**PREVOST**ENREGISTRÉ - REGISTERED
ISO 9001 & ISO 14001**SAFETY
RECALL**

Sr08-22

DATE : DECEMBER 2008	SECTION : 14-STEERING
SUBJECT : POWER STEERING HOSE INSPECTION AND REPLACEMENT

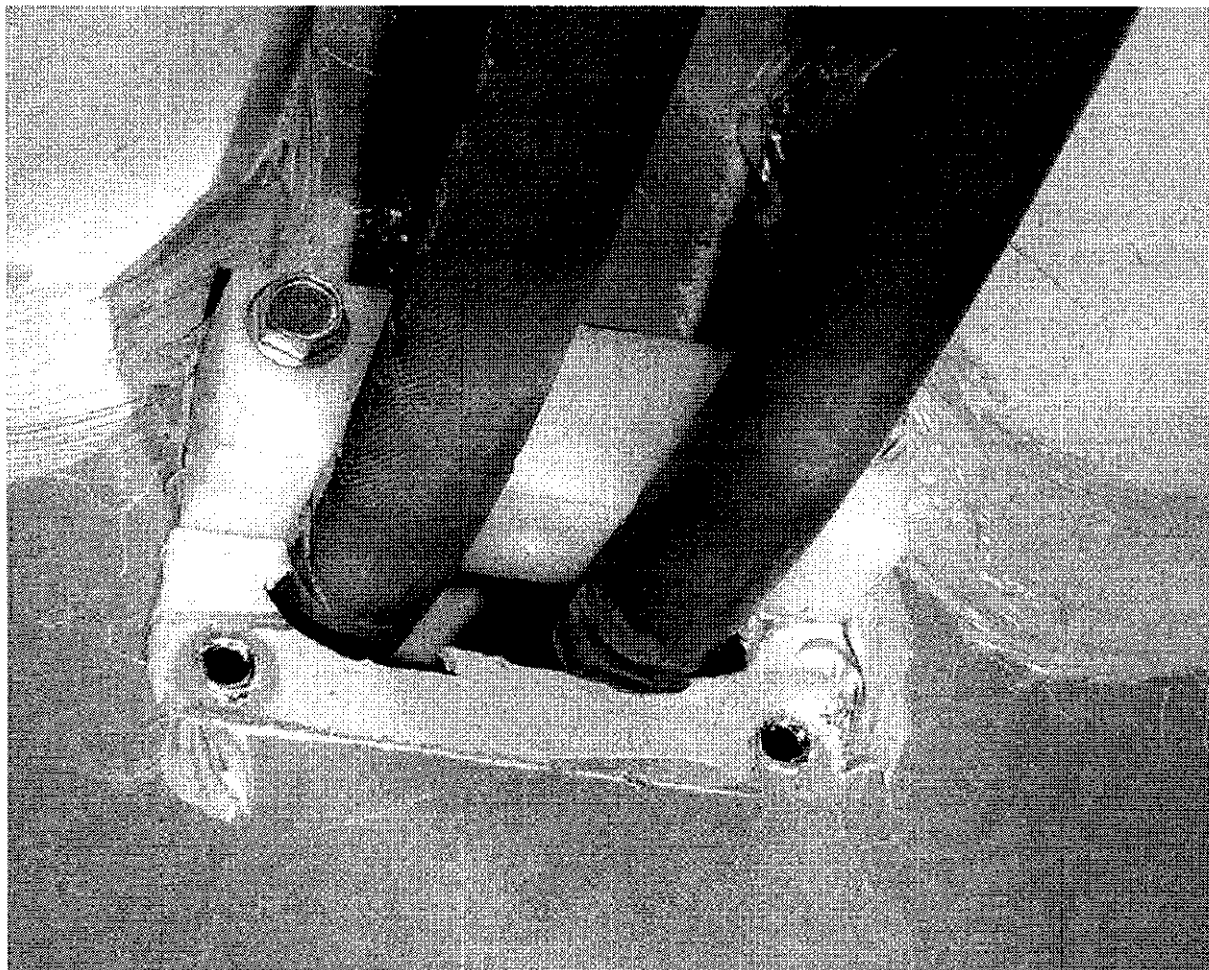
It has come to the attention of Prevost that on the vehicles affected by this recall, premature power steering hose wear located in the rear baggage compartment might occur and thus in the long term cause power steering system break down. Inspect the hoses mentioned below and replace them if it is necessary.

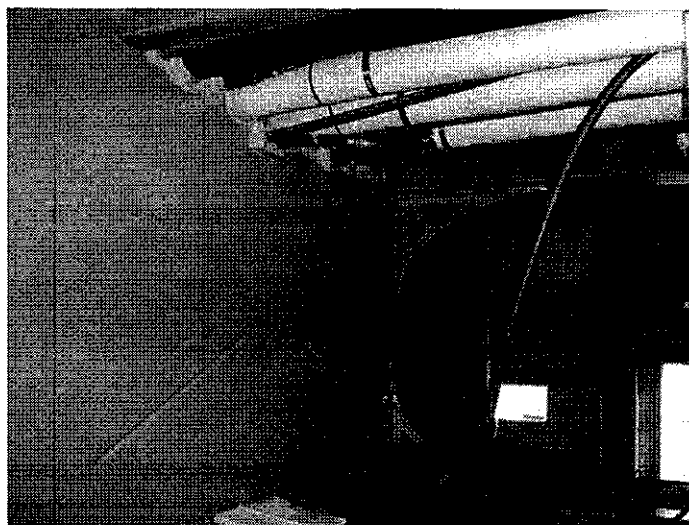
1. Disconnect hose fitting located above tag axle.
2. Remove hose brackets between fitting and rear baggage compartment partition wall.
3. Inside rear baggage compartment, cut worn hose close to the rear wall (near the white nylon fixing blocks).

4. Remove worn hose located between tag axle and rear baggage compartment.
5. Install new hose on vehicle starting with fitting above tag axle.

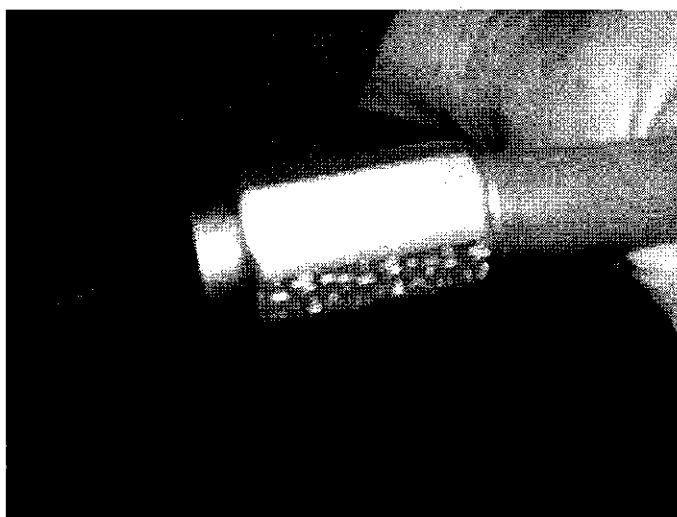
6. Secure hose to vehicle inside rear wheelhousing.
7. Replace former nylon plastic blocks inside rear baggage compartment with new ones with flared openings (160033).
8. Secure 2 nylon fixing blocks to hoses.
9. Apply some Sika 221 (680532) between the structure (wall) and the fixing blocks for watertightness.
10. Fasten the blocks to the rear baggage compartment wall.
11. Cut worn hose again so as to leave a 1 3/8 inch (35 mm) gap between front hose and the rear hose fitting end.
12. Clean and remove all residues from cut out area.
13. Fasten female part of fitting (501005) onto front hose (left-end thread).

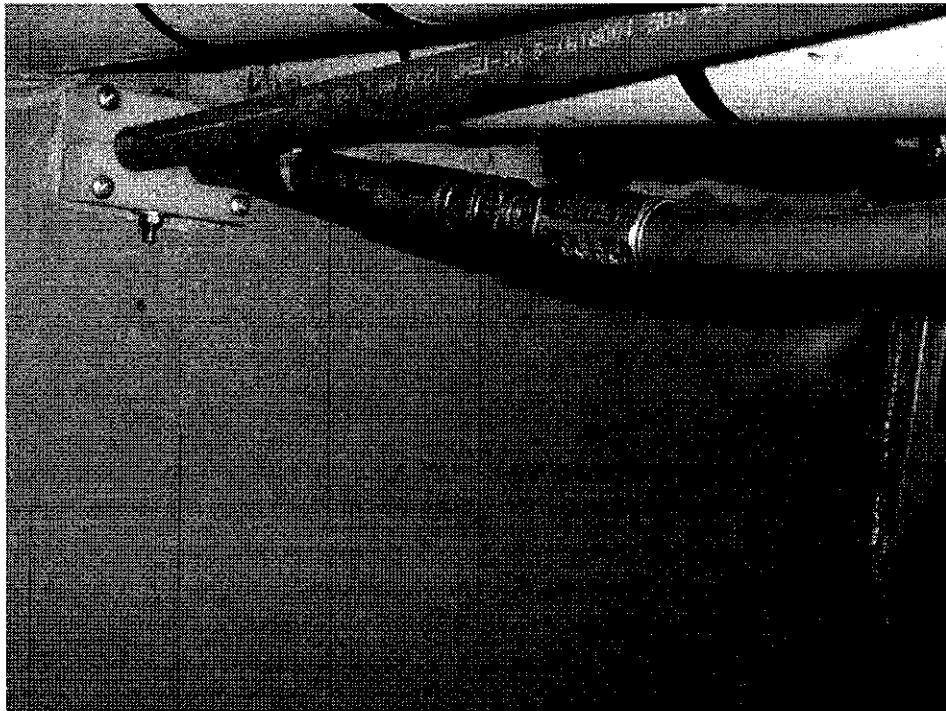
16. Secure hoses to the structural tubing using the green plastic supports.

NYLON BLOCK 504727 QTY 1
FIXING PLATE 504728 QTY 1
SCREW TC 1/4 X 20 500107 QTY 1

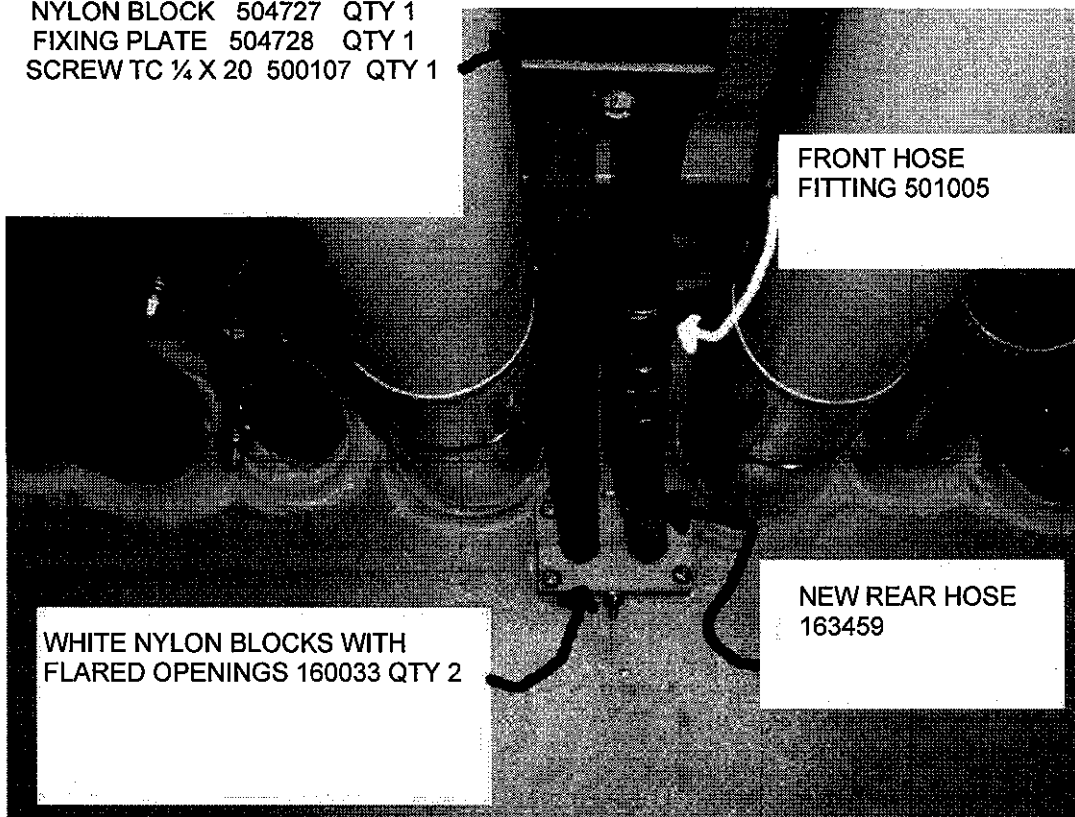
17. Add if necessary, a support inside the rear baggage compartment to prevent any contact between hoses or with surroundings.
